FORDPERFORMANCE

Technical Service Bulletin – 26

Optional Change

Catch Cans

Transmission Vent System

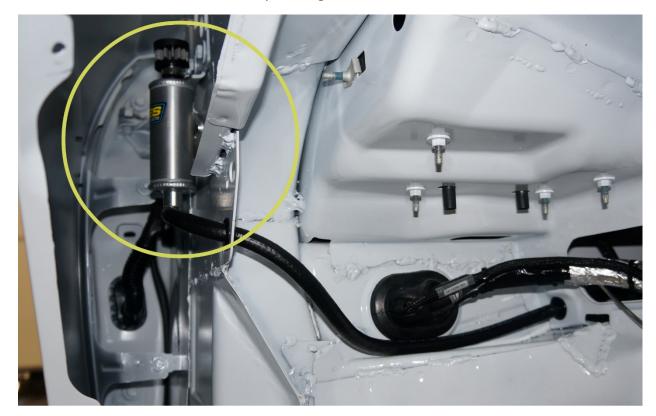
Original parts to be removed

• Vent/Tube Assembly MR33-7D494-AB

• ½" P-Clip 26-464

• Bolt M6x20 W505255-S450L

Located under the hood next to the engine breather can. $\,$

Mount location Drawings

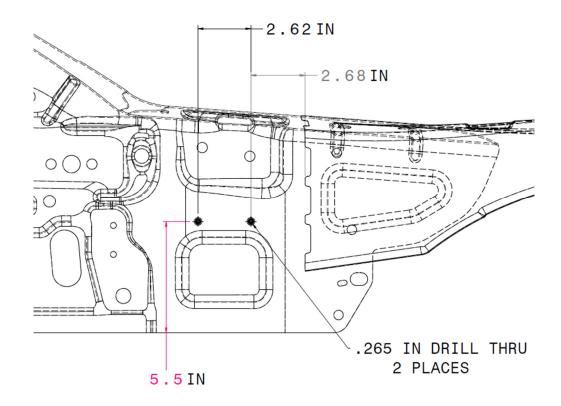
To be mounted behind the front passenger's side fender.
